Site monitoring report

Site Name: Highwood Quarry, Stortford Road, Little Canfield

Date: 1 August 2024

Extraction/Landfilling area progress

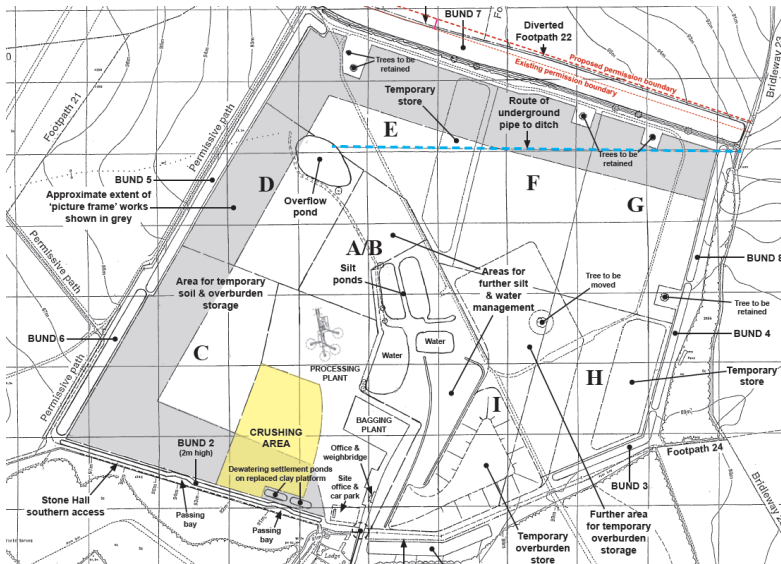
Extracting in last part of G and now moving into Phase H with landfilling in G. South section of H remain unstripped. Dust was rising from vehicles moving around the site, some could have been blowing out of the site. CT advised dust suppression inadequate JH confirmed by phone would address.
